City of Greenville
Planning Commission
Regular Meeting
4:00 PM February 17, 2022

Application by DHD Riley, LLC/Drew Schaumber for a **MULTI-FAMILY DEVELOPMENT** on approximately 5.75 acres located at **LOWNDES HILL ROAD AND I-385** for 88 units ("The Riley Overbrook") (TM# 019500-01-00201).

Planning Staff Report
Greenville Planning Commission
February 7, 2022
for the February 16, 2022 Public Hearing

1 CLUBHOUSE FRONT ELEVATION
SCALE: 3/16" = 1'-0"

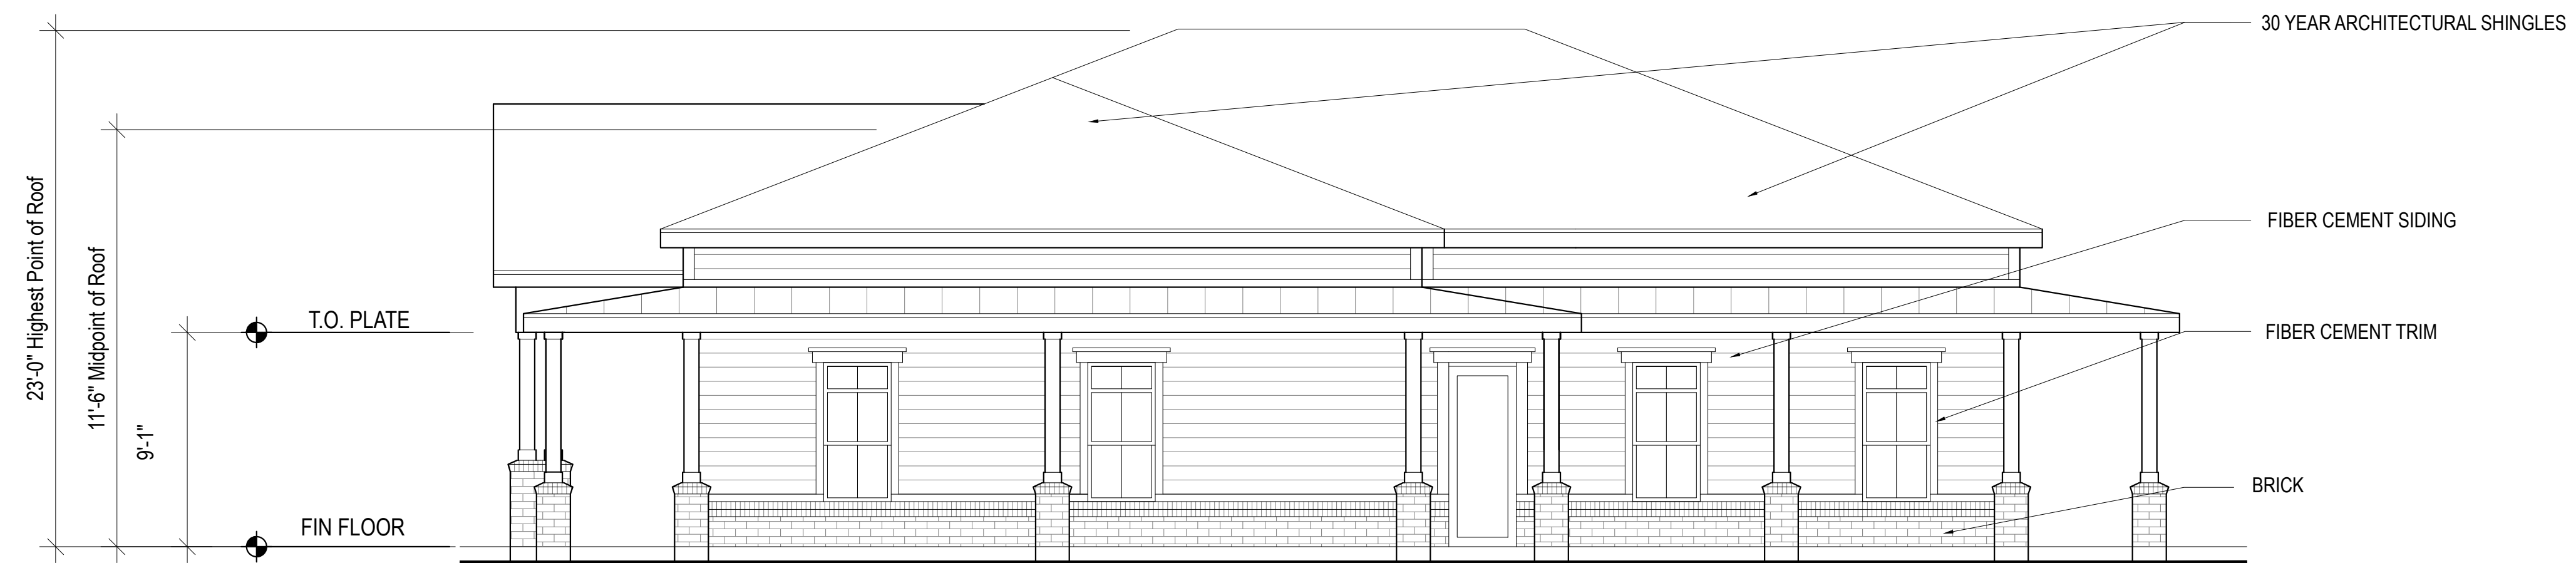
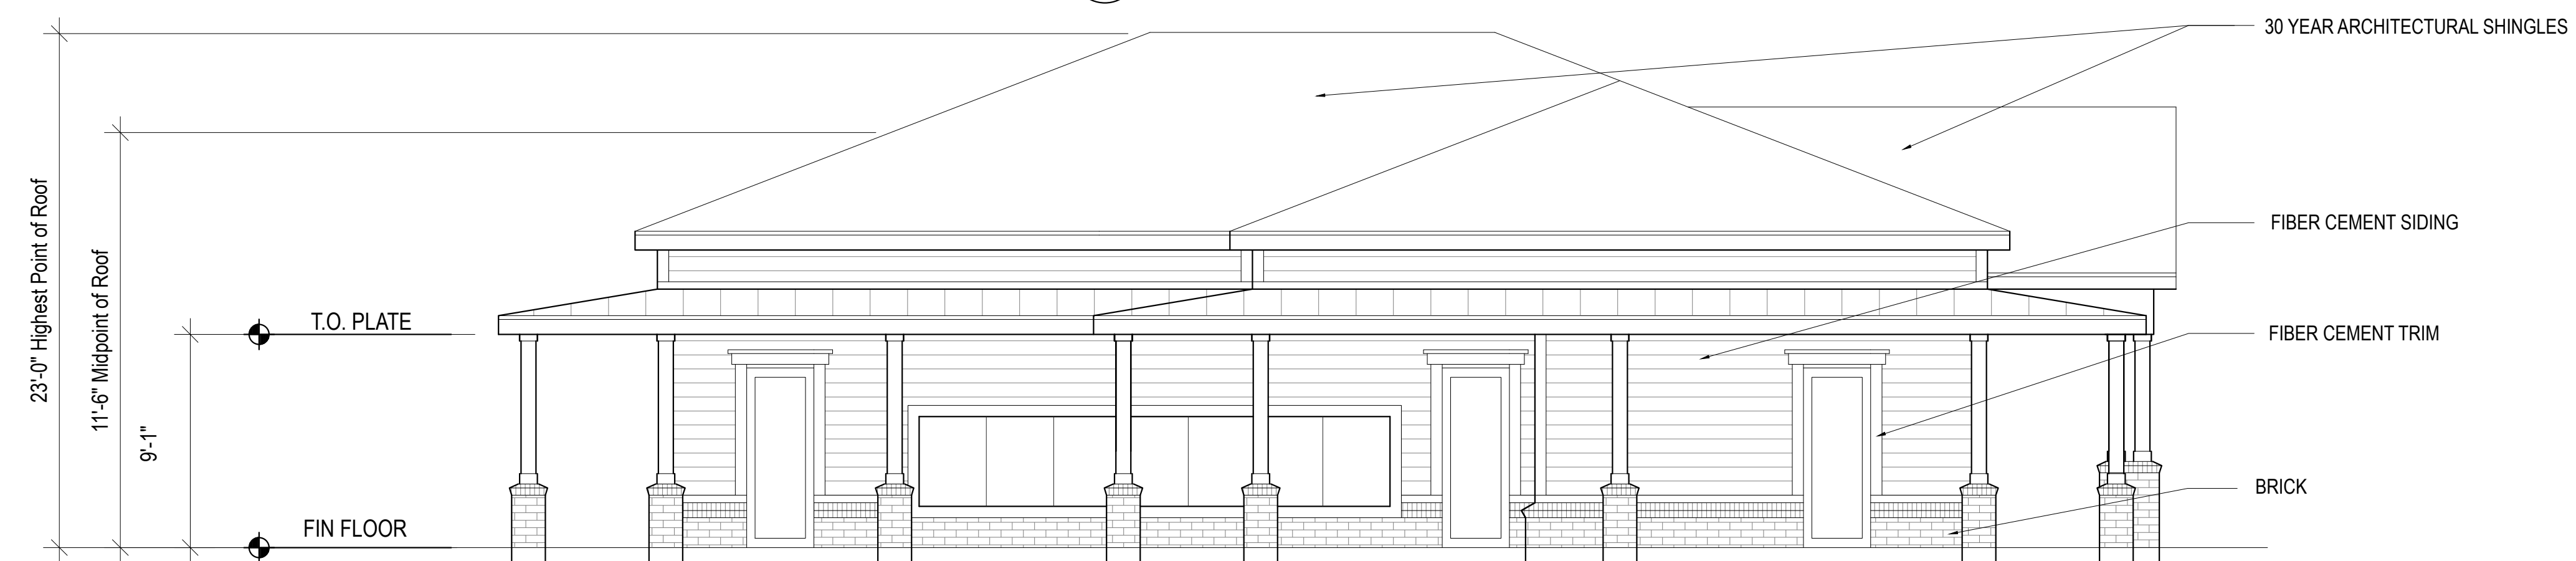
- The clubhouse should reflect similar design style to the main buildings.
- The statement that this is gateway architecture is a little amiss.
- The perspective drawings should show the buildings with the actual roofs as they are from a lower level so you can see what the actual view would be.

- 2) Prior to permitting, the applicant shall work with staff to provide updated façade materials for the clubhouse that are in keeping with those of the main buildings.

SITE PLAN

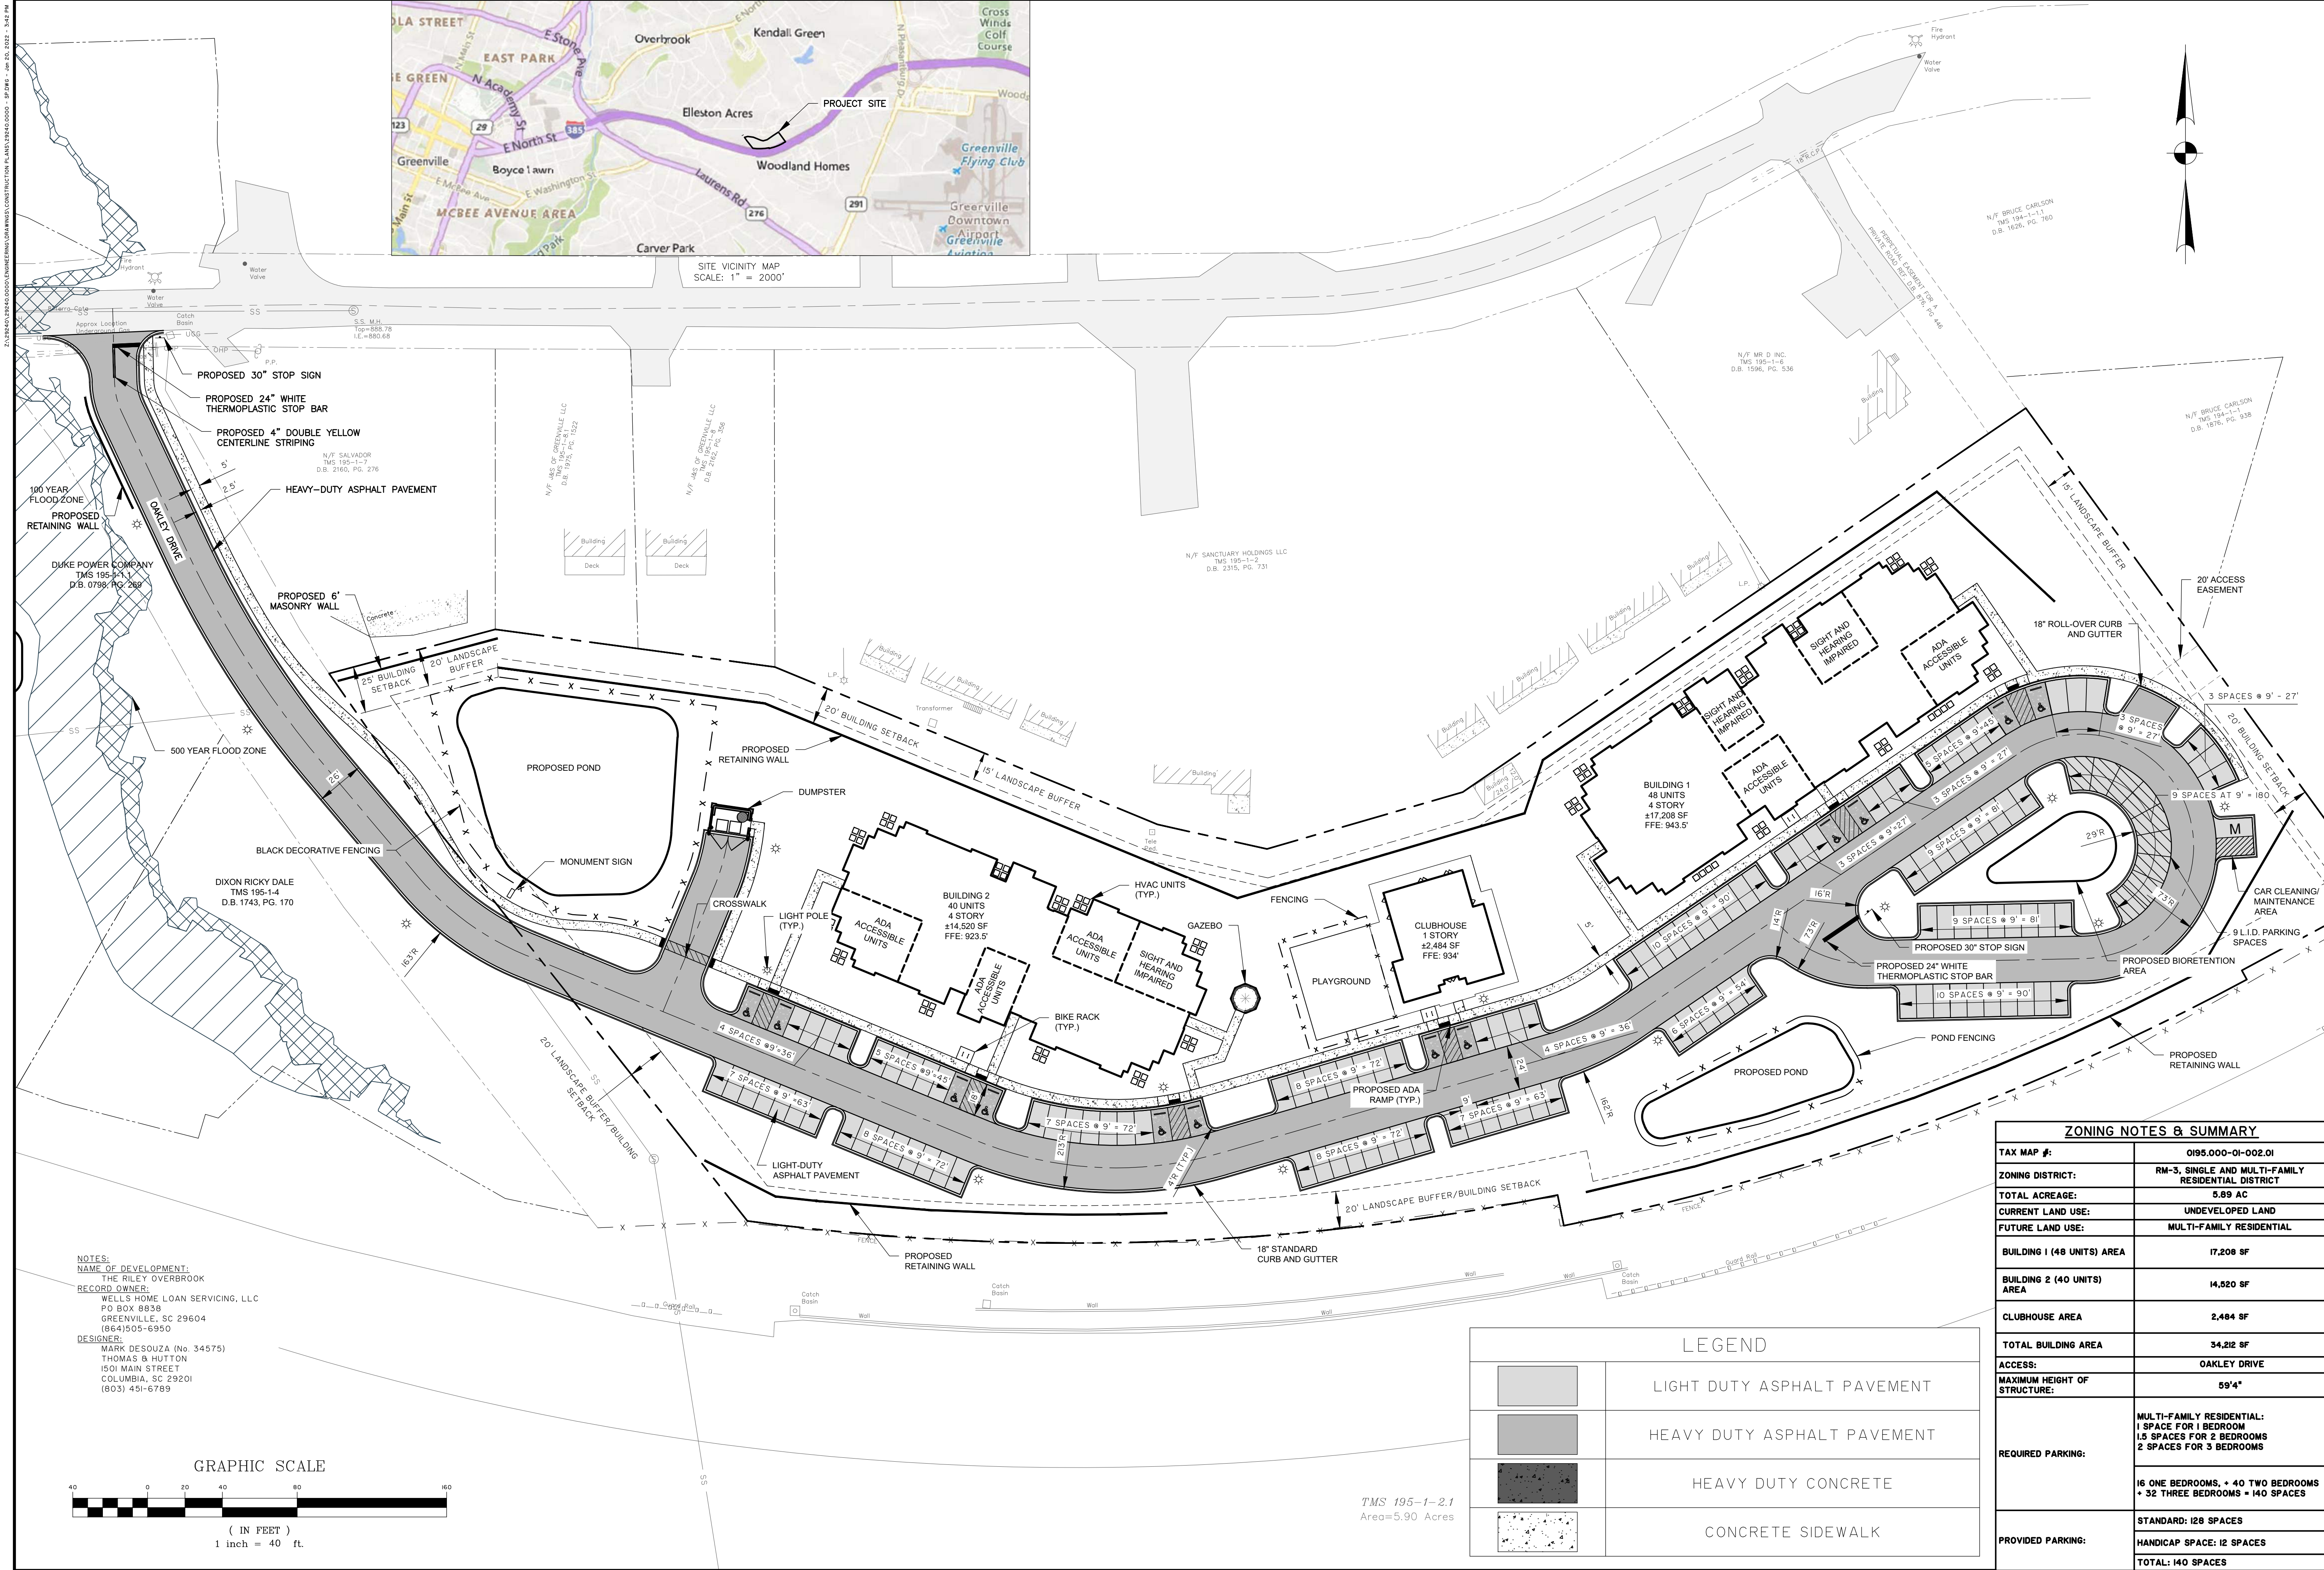
At time of site plan submittal, ensure compliance with 2018 IFC D105.1 is met for road widths in front of building 1 and 2 for aerial access.
